July 27, 2000 Water Licence Inspection - Report

MUNICIPAL WATER USE INSPECTION FORM

Date: 2000/07/27 Licensee Rep. (Name/Title): Noah Makayak / Foreman
Dennis Althouse / Utilidor System Manager
Licensee: Municipality of Rankin Inlet Licence No.: N6L3-0779 (expired)

figure 1. Final station along deep-water sewage discharge line; 2000/07/27.

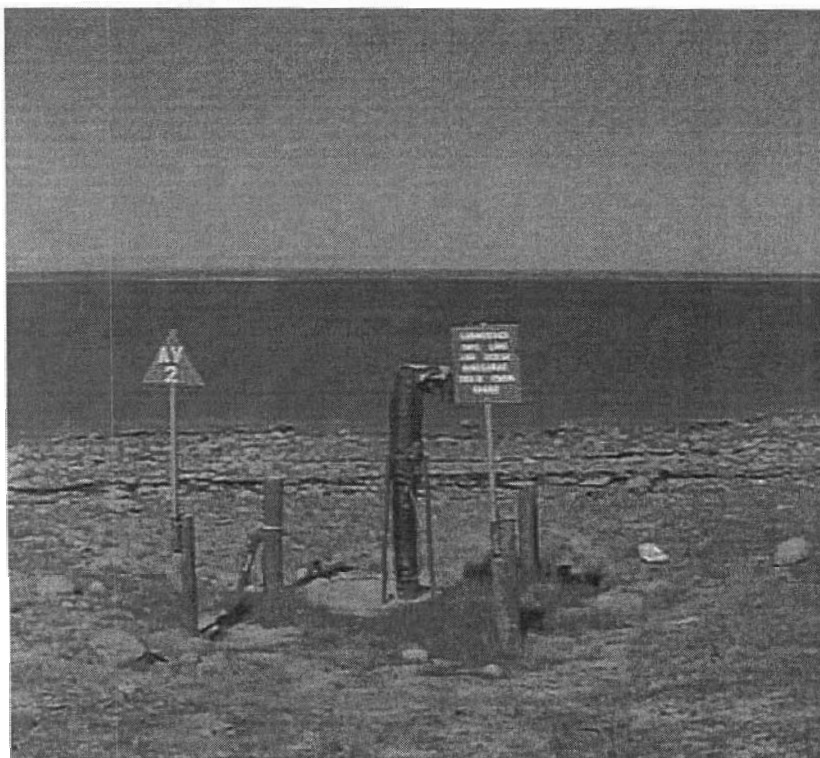
- **Sewage disposal:** Treated sewage is discharged to Prairie Bay via a deep water conveyance line (figure 1). However, the extent of the sewage treatment plant is minimal, being limited to a rotating screen (figure 2) which reportedly often raises the quantity of suspended solids in the effluent. It was also mentioned that upgrades to the water supply network had achieved a reduction in municipal water consumption, yet consequently reduced the dilution of the sewage discharge. Hence, the attached analytical results reveal that the treated sewage discharge at Surveillance Network Station (SNP) station 0779-3 does not meet the required effluent quality standards.

As such, the Municipality needs to ensure that the effluent from the sewage waste disposal facility meets the thresholds imposed within its Water licence, even if the Municipality neither directly owns nor operates the undertaking. Accordingly, by copy of this letter to the Department of Public Works and Housing (DPW&H), the Inspector recommends that the Municipality establish a closer work relationship with the owner/operator of the municipal water use and waste disposal facilities it is ultimately responsible for as Licensee of Water licence N6L4-0779.

figure 2. Rotating screen acting as sewage treatment plant; 2000/07/27.

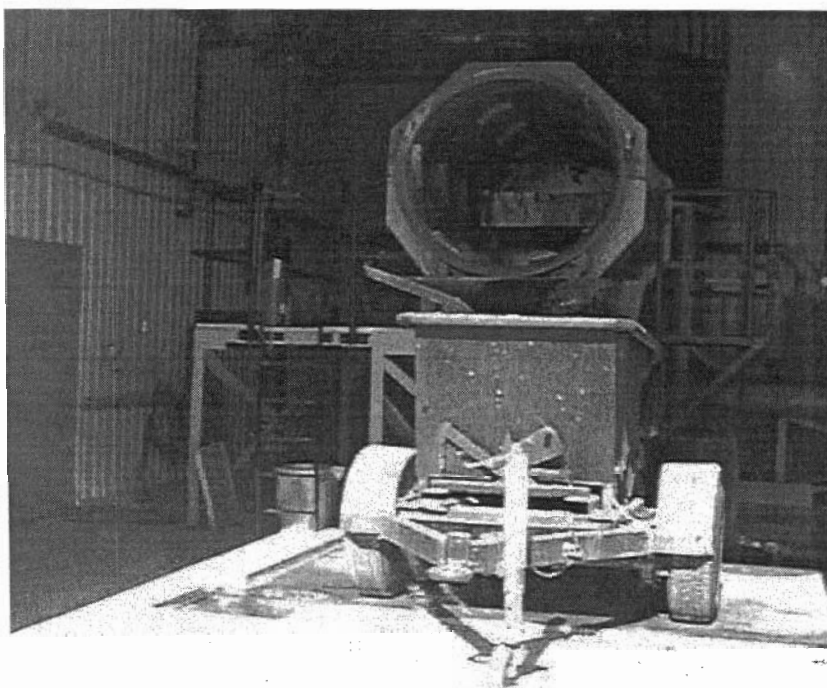
In parallel, Nunavut Water Board (NWB) approval has yet to be granted for the disposal of sewage screenings originating from the sewage treatment facility. Therefore, the Inspector requests that the Licensee either update or validate the attached memorandum relating to the now ongoing disposal of sewage screenings at the solid waste disposal site (figure 3). Formal NWB review could then proceed in a timely manner.

figure 4. Dumping area, solid waste disposal facility; 2000/07/27.

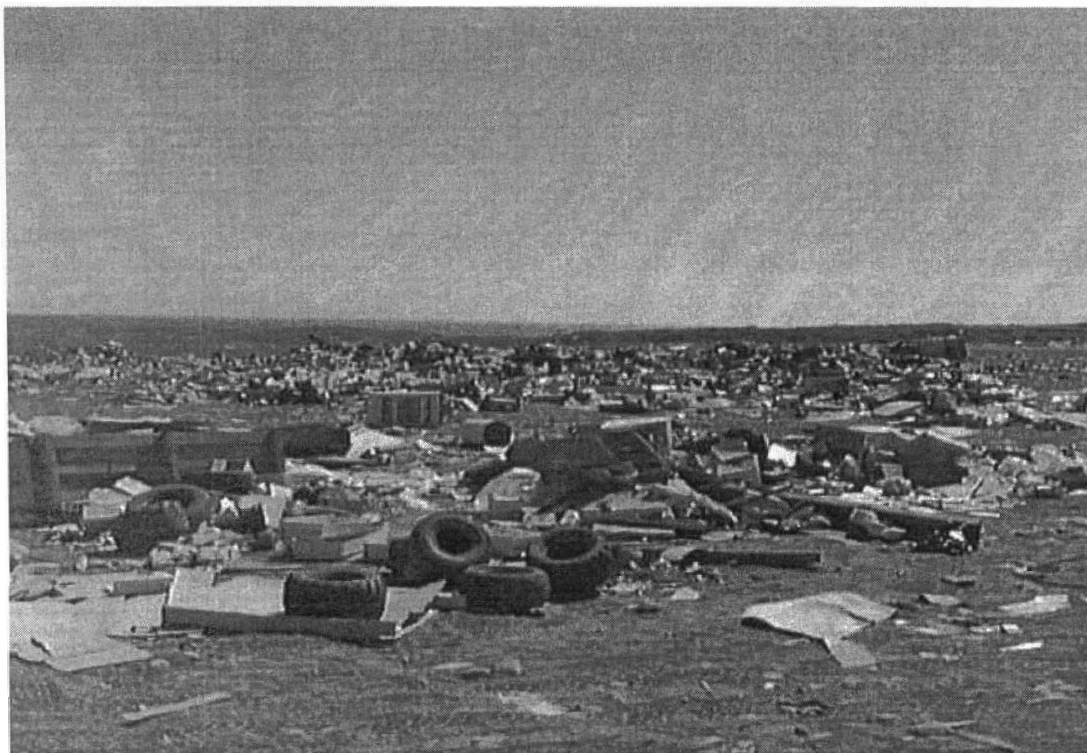
- **Solid waste disposal:** The solid waste disposal facility is now essentially a landfill, as prevailing wind conditions impede periodic burns. No segregation takes place at the general dumping area (figure 4), and waste is neither compacted nor covered. Accordingly, solid waste haphazardly litters an extensive area (figure 5). Furthermore, in addition to posing a wildlife attraction concern, gaps and breaks in the surrounding fence translate into a substantial quantity of windblown waste beyond the perimeter of the facility.
